**NOTICE OF
SPECIAL MEETING OF THE PLANNING AND ZONING COMMISSION
HICKORY CREEK TOWN HALL
1075 RONALD REAGAN AVENUE, HICKORY CREEK, TEXAS 75065
TUESDAY, JULY 30, 2024, 6:00 PM**

**Re: Founders Classical Academy of Corinth (Lot 1, Block A – Cornelius Town Center Addition)
Site Plan Addition
3rd Review**

**Re: Victory Hickory Creek (Lots 1-9, Block A – Lennon II Addition)
Preliminary Plat, Site Plan and Landscape Plan
4th Review**

SITE PLAN

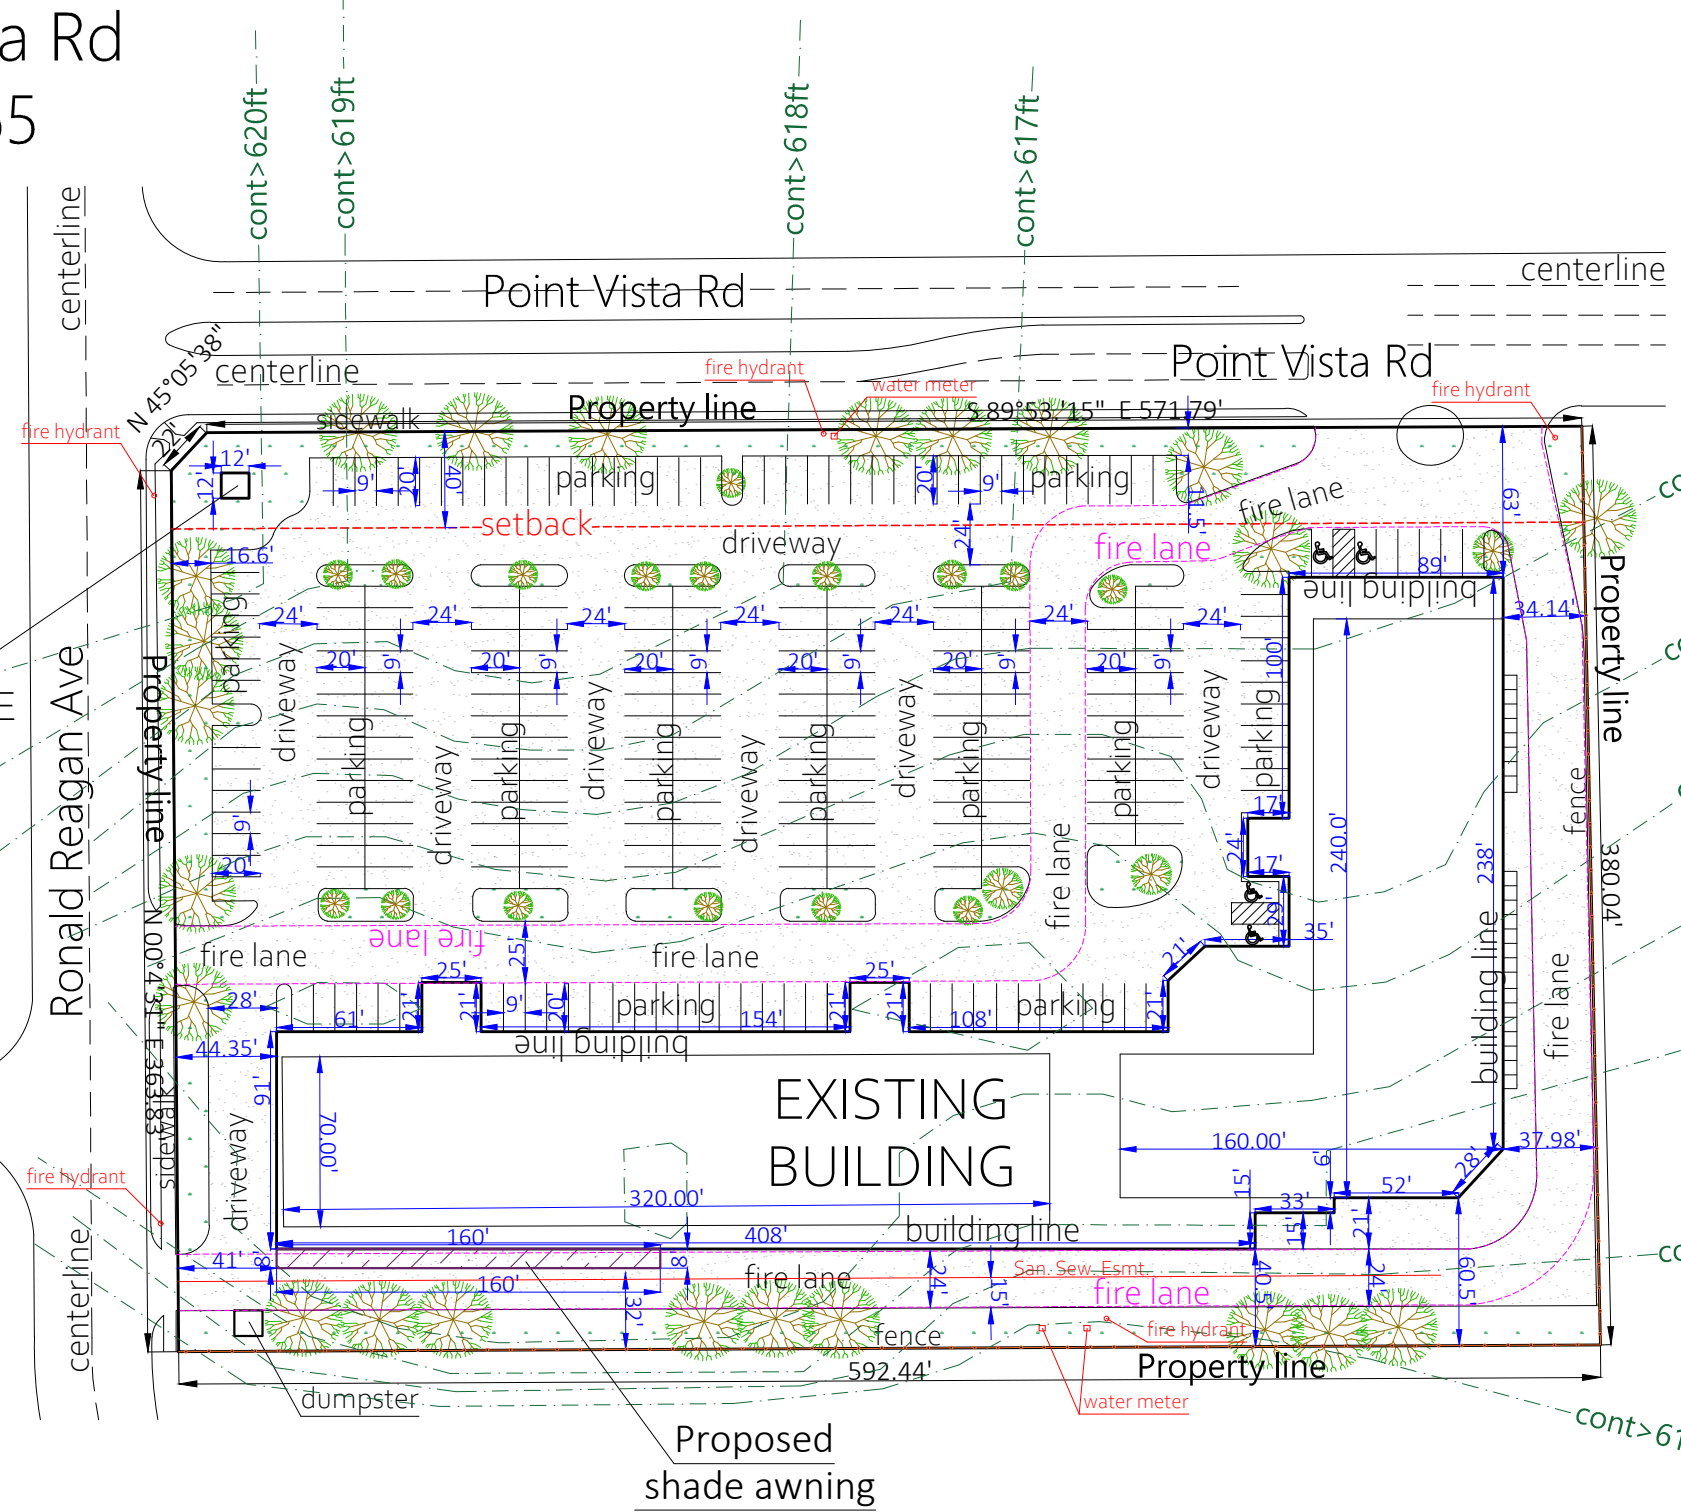
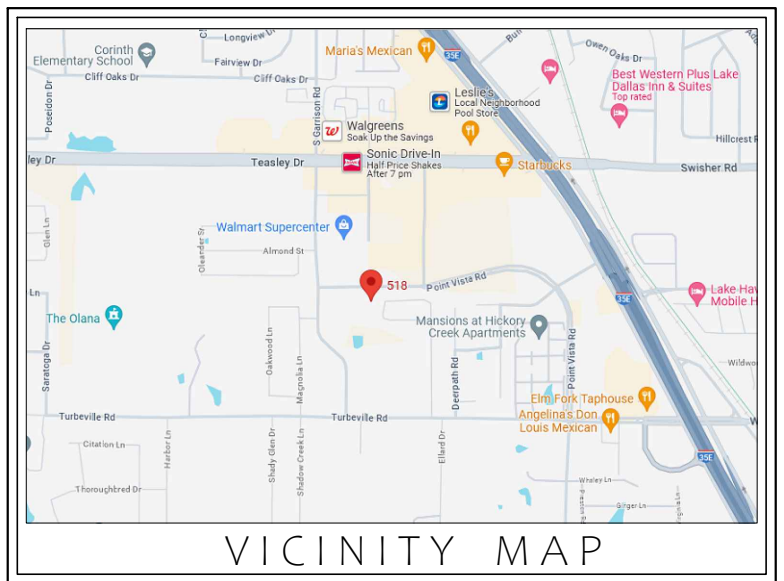
6. Please verify all called dimensions on the building site plan, especially in regards to the south of the building in proximity to the proposed shade awning (See Markup).
2nd Review: Some additional dimensions added, however, at least two dimensions checked are incorrect. Please confirm dimensions shown are correct. Refer to Markup.
3rd Review: Dimensions corrected, verified and/or clarified.

7. Please indicate the Fire Lane locations/route in the site plan (See Markup).
2nd Review: Addressed.
8. Please provide structural or architectural plans/details specific to the shade awning, including any cross sections, material, color, shop drawings, and elevations that are signed/sealed by a Texas licensed professional engineer or architect (See Markup and Checklist).
2nd Review: Applicant included hand-drawn details of awning for Building Department review; however, the details are not signed/sealed by a licensed professional engineer or architect.
3rd Review: Addressed. Shade Awning Details have been signed and sealed by a licensed professional engineer.

As per the Fire Marshall, David Rodriguez, the structure will not encroach within 2 feet of the fire lane. Max width 8'
Excess excavation is not anticipated for this project due to the fastening method.

* Awning - Metal; White Roof Black Posts, Height 9 feet, Width 8 feet, Length 160 feet *
